To: Suzanne Wylde, EPA
 From: Margot Cronin, MI
 Re: S0028-01 Dumping at Sea Permit Application for Killybegs Harbour

Introduction: The Department of Agriculture, Food and the Marine's proposed pier extension involves an application for disposal at sea of approximately 97 000m³ of mixed sands, silts and gravels to be dredged from Killybegs harbour. The application states that the top 750mm of seabed (17 600 m³) is not intended for dumping at sea and will be disposed of on land. Approximately 14000 m³ of rock will be retained and used in future harbour projects.

Figure 2. TBT concentrations in sediment samples from 2015. Green indicates clean, orange indicates slight to moderate contamination, red indicates heavy contamination. Note: The larger the marker, the higher the DBT&TBT concentration.

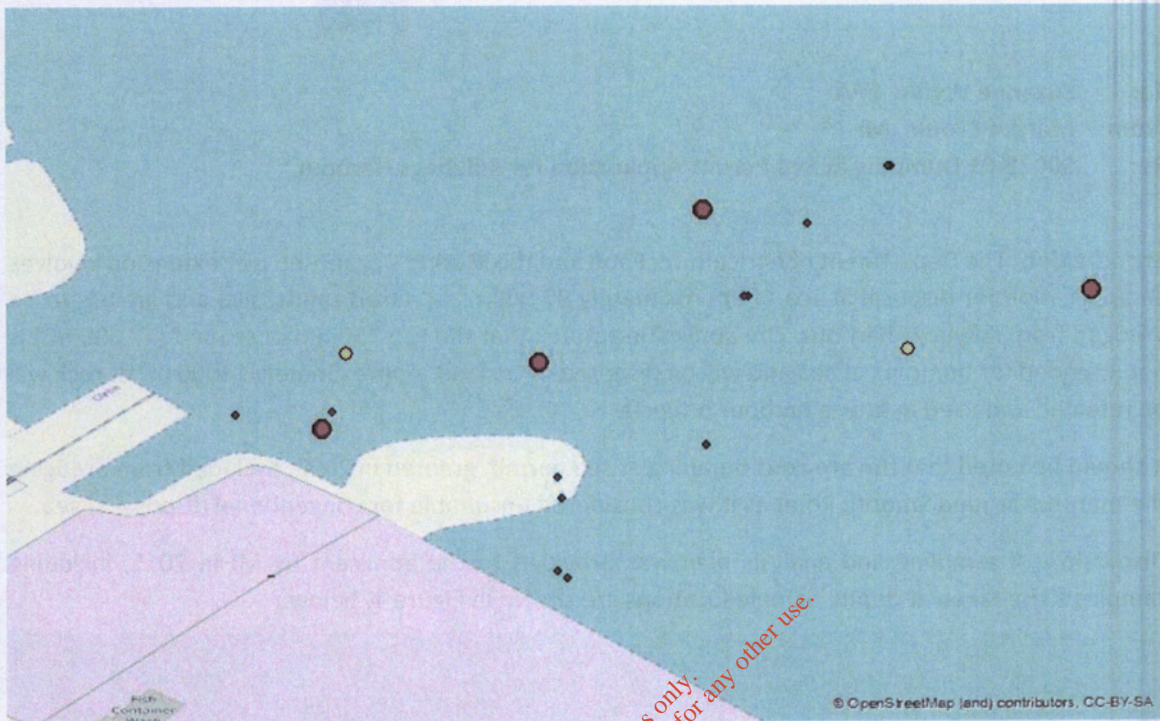
The results of the analyses indicate widespread moderate/heavy TBT and DBT contamination in surface and sub-surface sediment (see Figure 2 below). Sediment along a line running west-north-west around Smooth Point from the synchrolift show highest levels of TBT and DBT contamination. This is to be anticipated owing to historic activity at the synchrolift from which much TBT will have

originated during sandblasting prior to painting and/or refits, and the apparent net outward flow carrying the lighter fractions of sediment in that direction.

There is evidence of Class 3 TBT contamination in one sample (13D) taken at a depth of one metre. Of the remaining sub surface samples, one had TBT at very low concentration, while at the other four, TBT was below the limit of detection.

There is also evidence of predominantly low Class 2 contamination, including copper, zinc, cadmium and PCB in surface sediment at stations 4, 6 and 9, again following the distribution pattern seen with TBT. Although the concentrations for arsenic and nickel are also low class 2, these are most likely associated with natural geological variation, and may be regarded as background for that area.

Figure 4. TBT concentrations in surface samples taken in 2016. Green indicates clean, orange indicates slight to moderate contamination, red indicates heavy contamination. Note: The larger the marker, the higher the DBT&TBT concentration.

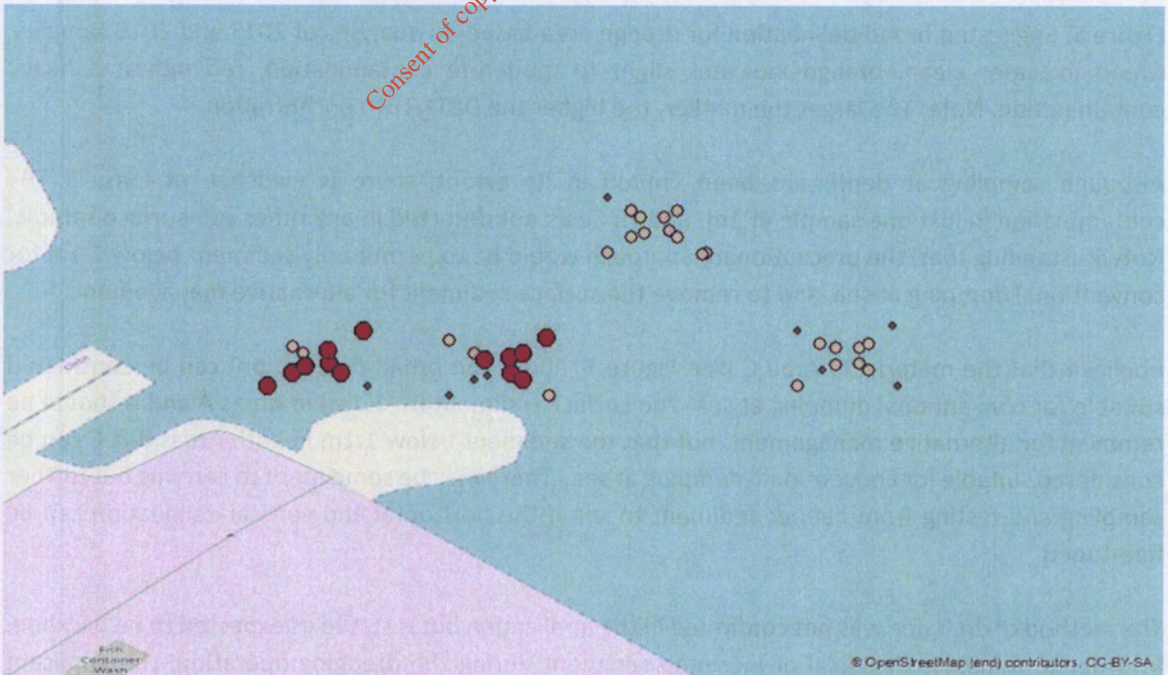
These samples were analysed for TBT & DBT only. Results confirmed widespread surface contamination, with Class 3 levels of contamination in sediment found closer to the synchrolift and Class 2 levels of contamination further out. Figure 4, below, demonstrates the extent of the contamination.

Figure 5. Suggested broad delineation for dredge area based on analyses of 2015 and 2016 samples. Green indicates clean, orange indicates slight to moderate contamination, red indicates heavy contamination. Note: The larger the marker, the higher the DBT&TBT concentration.

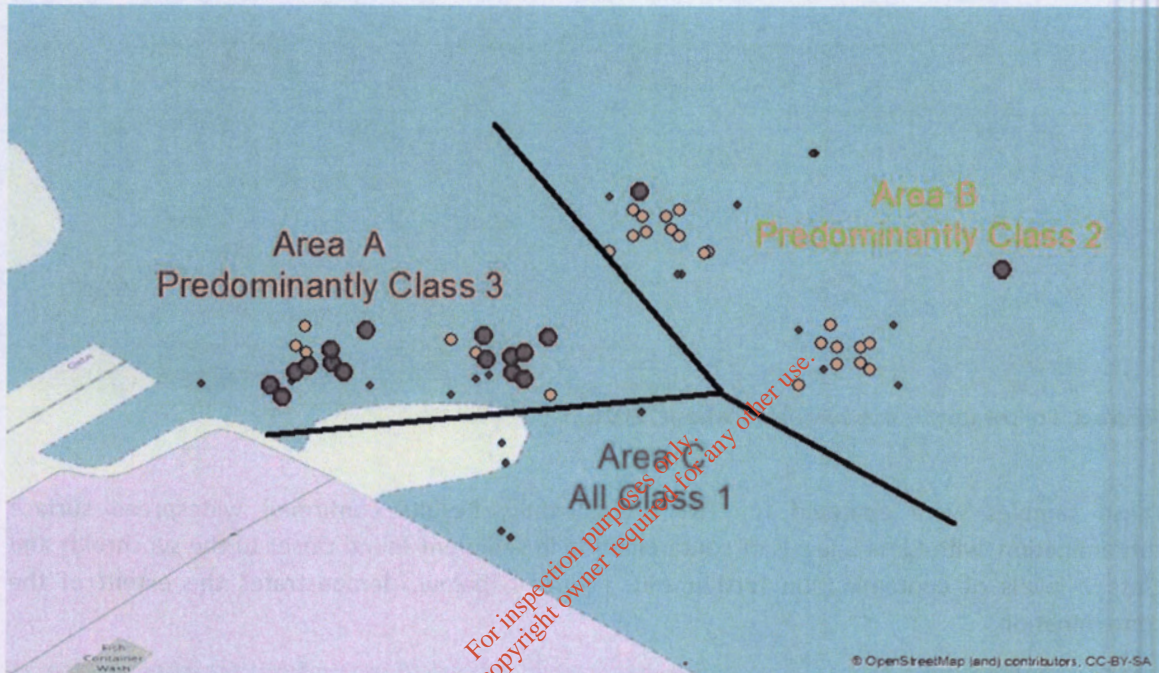
Summary and recommendation: In summary, 26 out of 67 samples are categorised as Class 3, or heavily contaminated sediment, with a further 18 ranked as Class 2, or moderately contaminated sediment.

It is apparent from the layout of analysis results that the extent of the contamination is quite broad, and particularly elevated closest to the synchrolift, however, there appears to be an area along the southern part of the dredging area that can be categorised as Class 1 (essentially clean). See Figure 5, below.

Although sampling at depth has been limited in its extent, there is evidence of Class 3 TBT contamination in just one sample at 1m, and TBT was not detected in any other sub-surface sample. Notwithstanding that, the precautionary approach would be to permit only sediment below 1.1m for conventional dumping at sea, and to remove the surface sediment for alternative management.

I believe that the material in Area C (see Figure 5, above, on broad delineation) can be considered suitable for conventional dumping at sea. The surface sediment (to 1.1m) in Areas A and B should be removed for alternative management, but that the sediment below 1.1m in both Areas B & C can be considered suitable for conventional dumping at sea. There may be some merit to carrying out further sampling and testing from deeper sediment to see if the horizontal and vertical delineation can be fine-tuned.

The method of dredging was not confirmed in the application but is stated as expected to be backhoe. In order to minimise dispersal of loosened sediment during the dredging operation, the applicant should be required to use an environmental grab, or some other such containment method, to remove the surface contaminated sediment.
